ADDENDUM NO. 4

PROJECT NAME: East Campus Recreation Center Renovation and Addition
UNL PROJECT NUMBER: A016P039
BID INVITATION NUMBER: 2237-13-7200

DATE OF ISSUANCE: Wednesday October 2, 2013

Revision to Detail: **A1/A502**

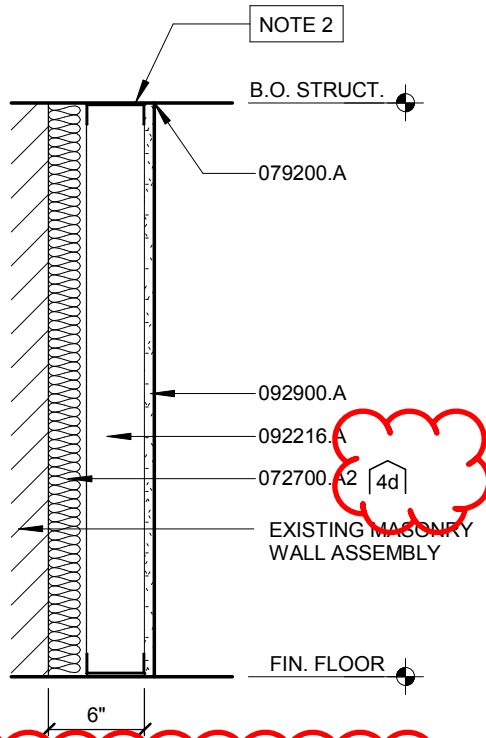
ADD 4-34. Refer to A1/A502, Frame Type CW-1; Add a horizontal SSG mullion (084113.B) at EL. = 112'7 1/4" to bottom of mullion as shown on Attachment A2.
